Order Number:	CPO 0310 6377 DNR2000000012 6	Procurement Folder:	697731
Document Name:	Bowden Hatchery 3 - New Facilities Construction	Reason for Modification:	
Document Description:	Change Order No. 04- Bowden Hatchery 3- New Facilities Const	Change Order No. 04 to exter contract per the attached door	
Procurement Type:	Central Purchase Order		
Buyer Name:	Joseph E Hager III		
Telephone:	(304) 558-2306		
Email:	joseph.e.hageriii@wv.gov	×	
Shipping Method:	Best Way	Effective Start Date:	2020-08-31
Free on Board:	FOB Dest, Freight Prepaid	Effective End Date:	2022-06-03

Re: Change Order No. 4 (Revised)

Bowden Fish Hatchery Contract 3 – New Facilities CPO 0310 6377

Change Order Number: 004

Bowden Cop16 Sketch KCS 4/22/21

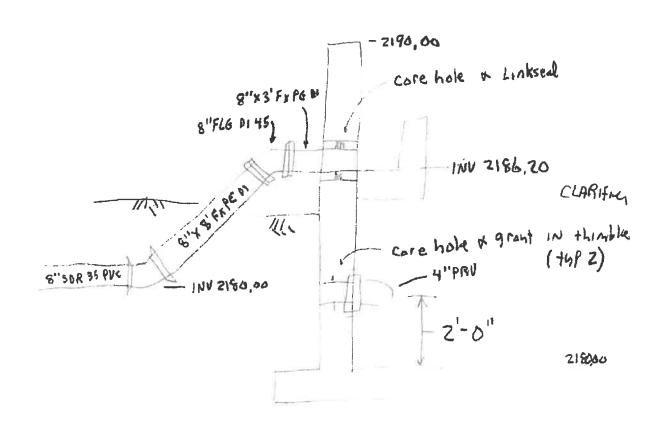
Change Order Proposal # 16 - Relocate Clarifier PRV's and Change Clarifier Effluent pipe to Dl

As directed by email dated March 23, 2021 and at the April 7, 2021 job meeting, we are pleased to provide the following change order proposal to relocate the 2 each 4" wall type pressure relief valves in the clarifier to 2-foot above the floor slab and to change the above grade clarifier effluent piping from pvc to ductile iron (see attached sketch)

We propose to perform the above work for the lump sum price of \$6,690.00 (Six Thousand Six Hundred Ninety dollars) (Please see attached breakdown for more information).
